FIELD CHANGE NO. 2

RECORD DRAWING
09/04

TITLE: CENTRAL – ATRISCO DRAINAGE IMPROVEMENTS
46th STREET
PLAN & PROFILE STA. 20+00 TO 25+25.00

City Project No.	Zone Map No.	Sheet	Of
674902	K-12-Z	3.2	21

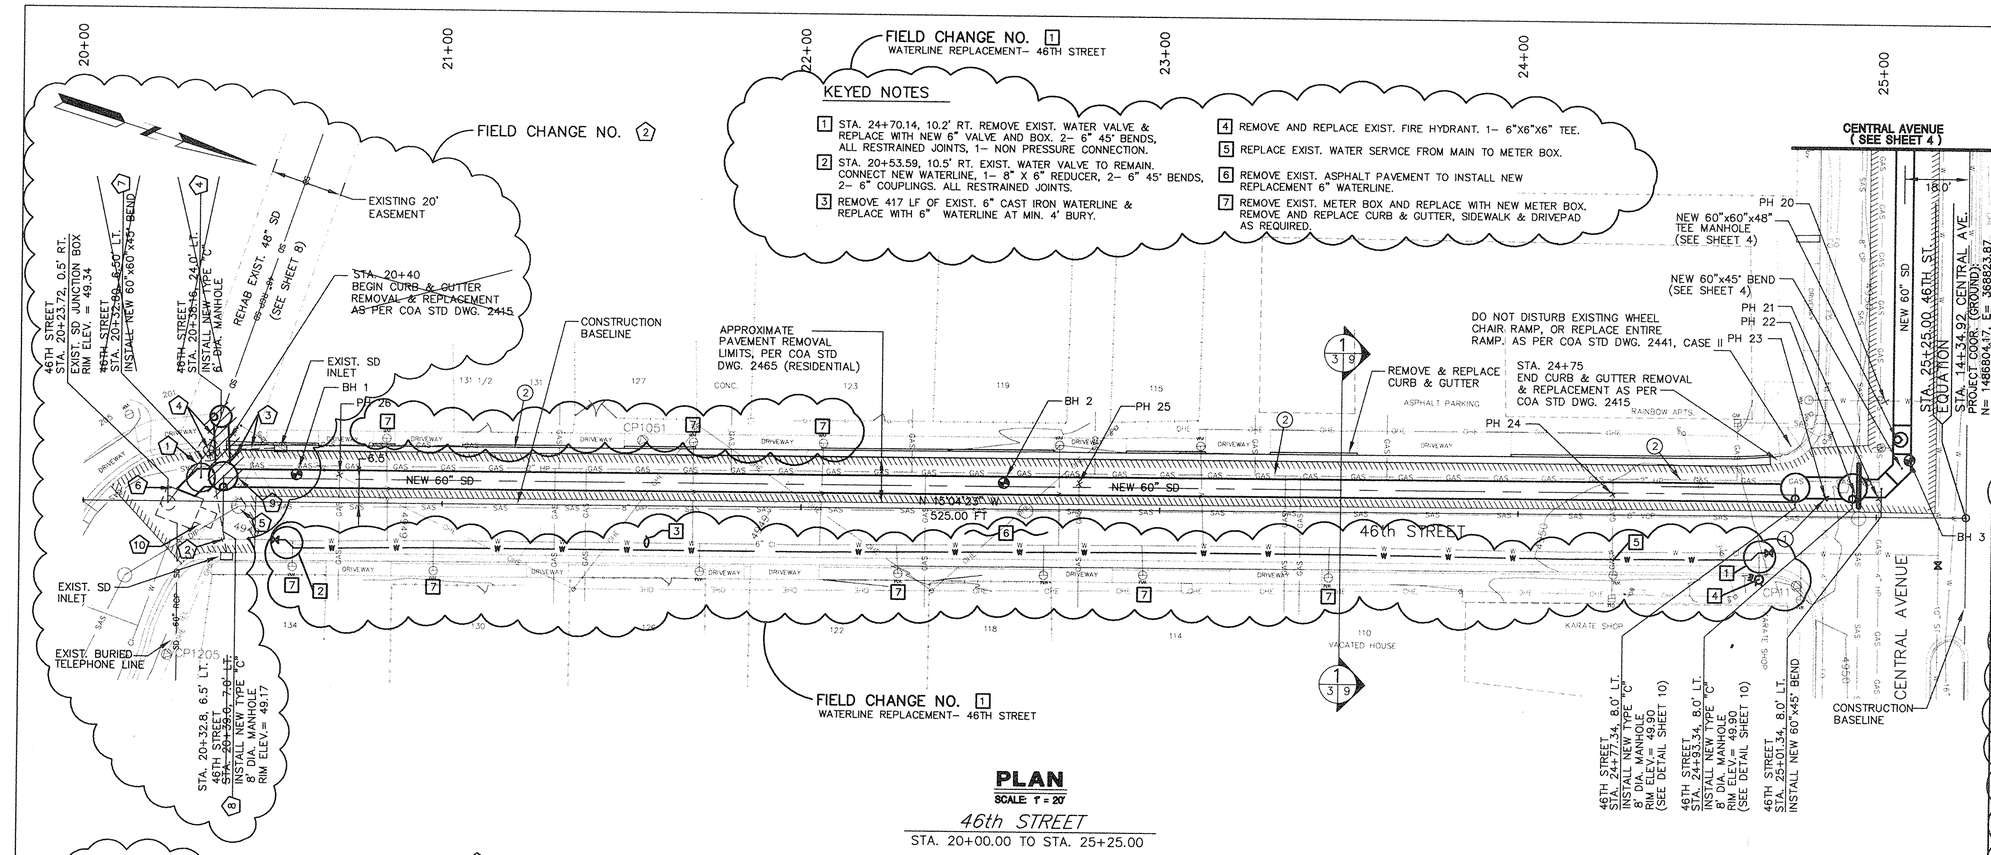
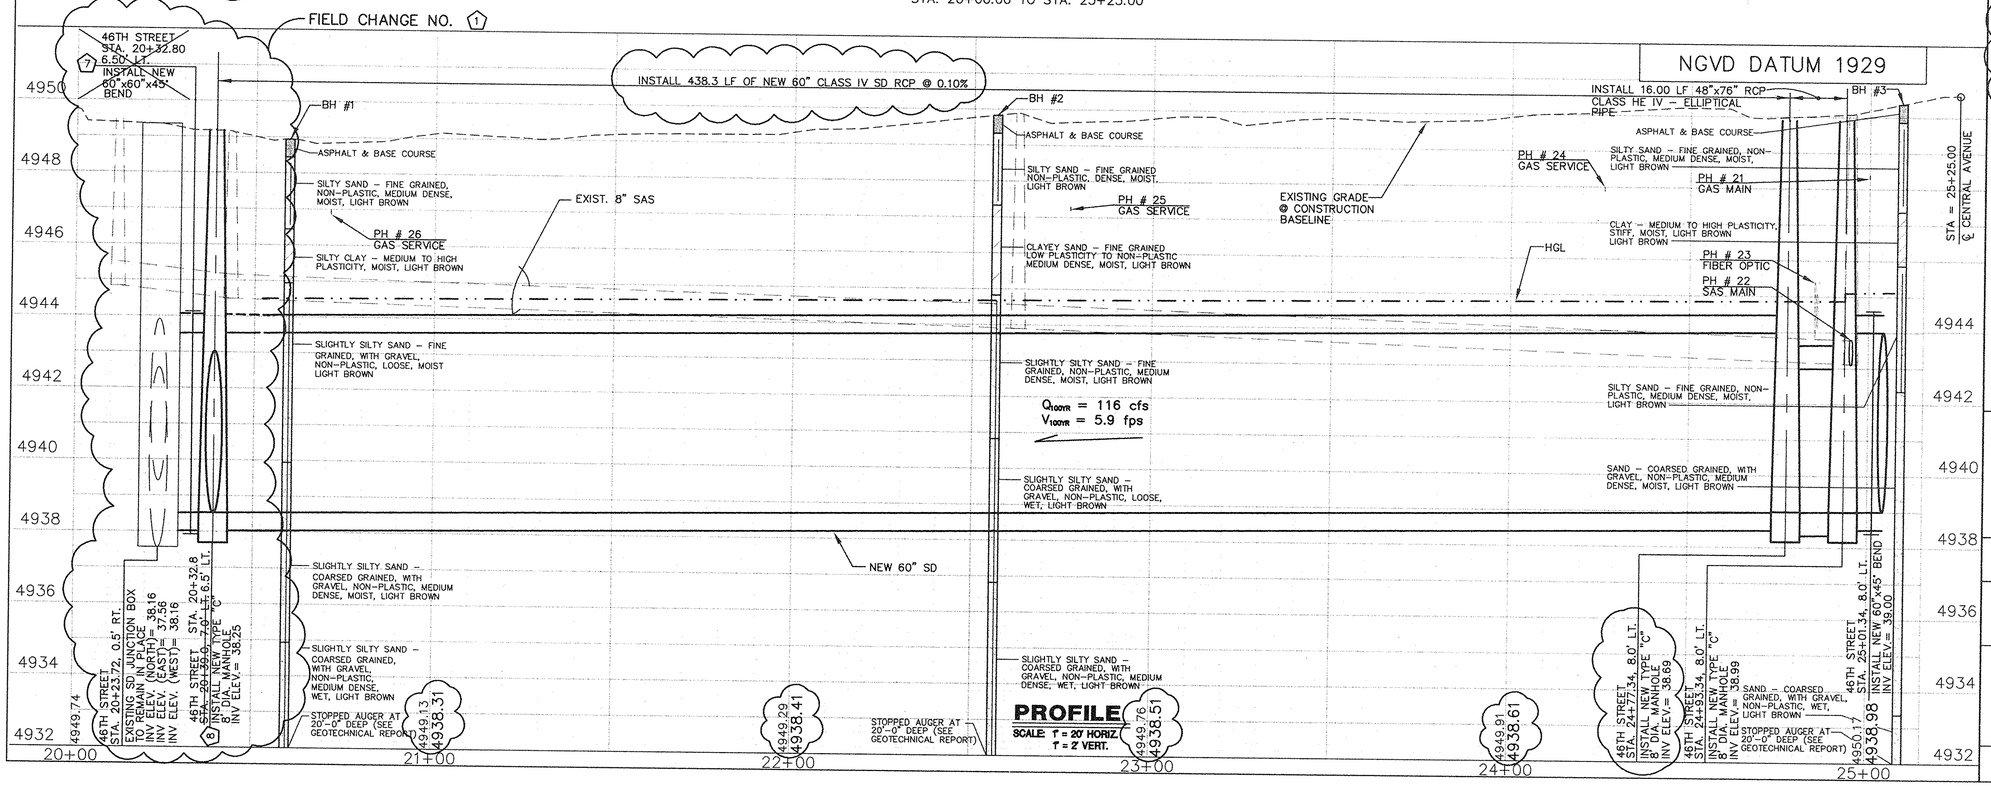
1. REMOVE APPROX. ~~12~~ 8 LF OF EXIST. 48" RCP BETWEEN EXIST. JUNCTION BOX AND EXIST. MANHOLE.
2. REMOVE APPROX. 20 LF OF EXIST. 18" RCP LATERAL LINE. RECONNECT TO NEW 8' DIA. MANHOLE.

7. ~~INSTALL 60"X60"X45° BEND.~~
8. BUILD 8' DIA. TYPE C MANHOLE.
9. INSTALL 60" DIA. CLASS IV RCP ~~STARTING AT STA. 20+42.50, 6.50' LT. INV. EL.= 38.25.~~
